RFQ NUMBER
DEP14244

LINE	QUANTITY	UOP	CAT NO	ITEM NUMBER	UNIT PRICE	AMOUNT
0001	1	JB		962-73		
<p>*****            ADDENDUM NO. 1 *****            ADDENDUM ISSUED FOR THE GREEN MOUNTAIN ENERGY PROJECT TO DISTRIBUTE THE TWO PAGES OF SIGN-IN SHEETS, THE TWO PAGES OF Q/A RESULTING FROM THE 02/28/08 MANDATORY PRE-BID MEETING, AND A REVISED DRAWING TO REPLACE PAGE 56 OF THE SPECIFICATIONS.            THE BID OPENING DATE AND TIME REMAIN UNCHANGED AS 03/27/2008 AT 1:30 PM.            ***** NO OTHER CHANGES *****</p>						
RECLAMATION: RESTORATION OF LAND

**DEP14244**  
**Addendum No. 1**

**Pre-Bid Conference**  
**February 28, 2008**  
**Questions and Answers**

SPECIAL RECLAMATION	
SPILLWAY CONCRETE SEEPAGE CUTOFF TYPICAL	
SCALE: Not To Scale	DRAWN BY:
DATE:	PROJECT NO.:

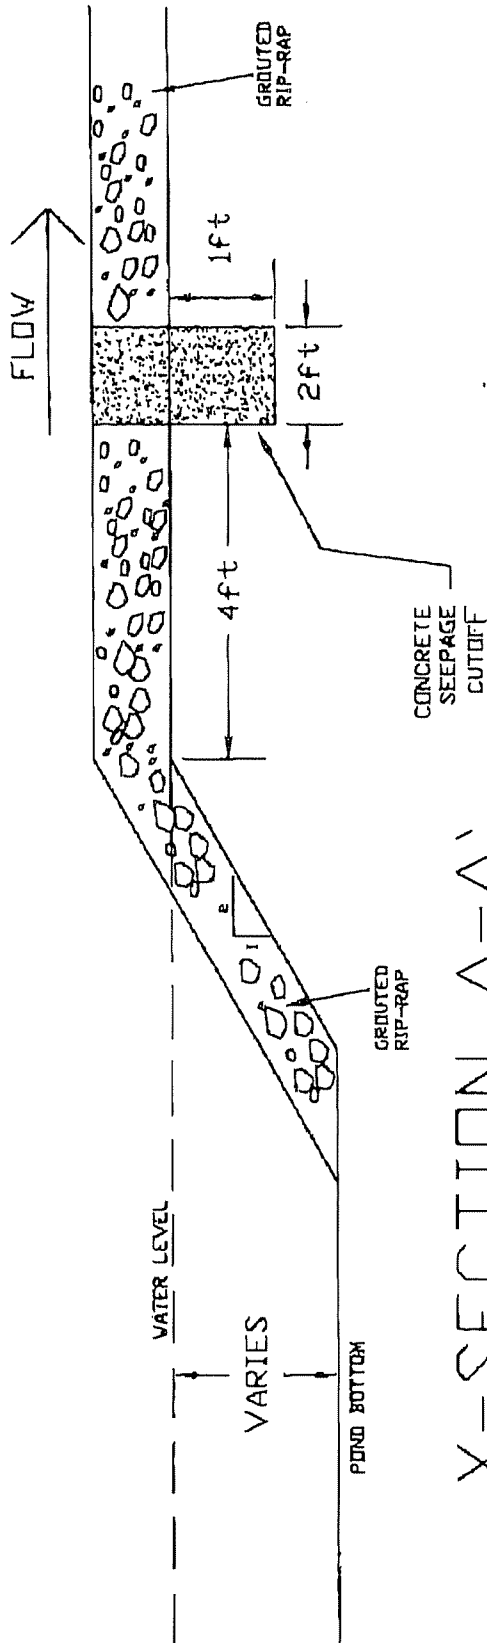
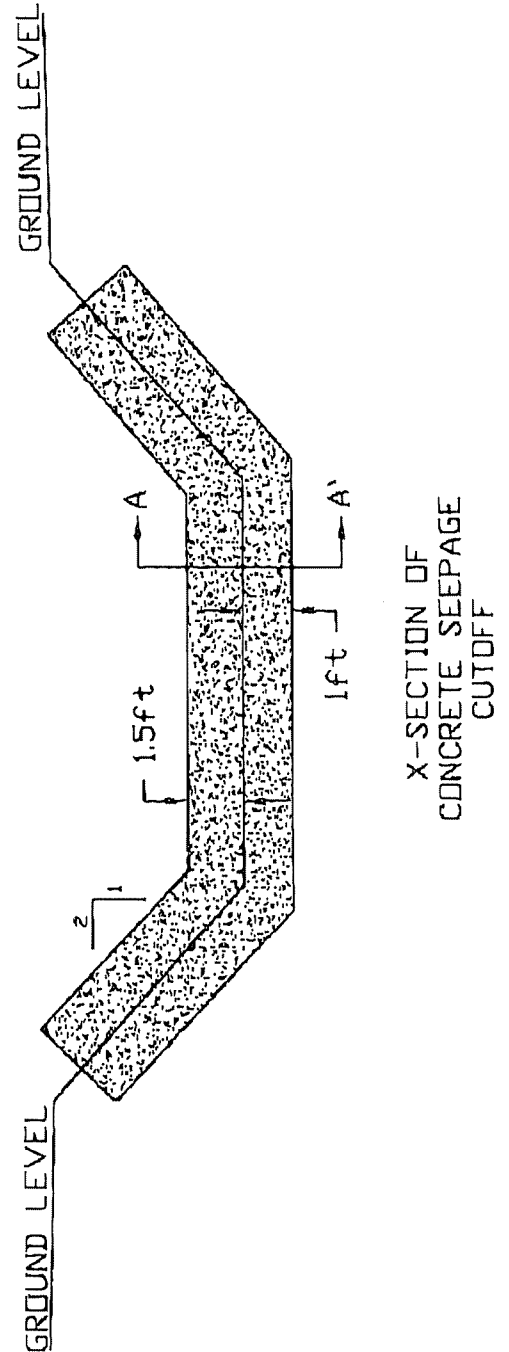
In attached drawings: Existing page number 056 shall be removed and replaced with the enclosed Page number 056, labeled "Revised 2/28/08". (See Page 3 of 3)

REVISED 2/28/08
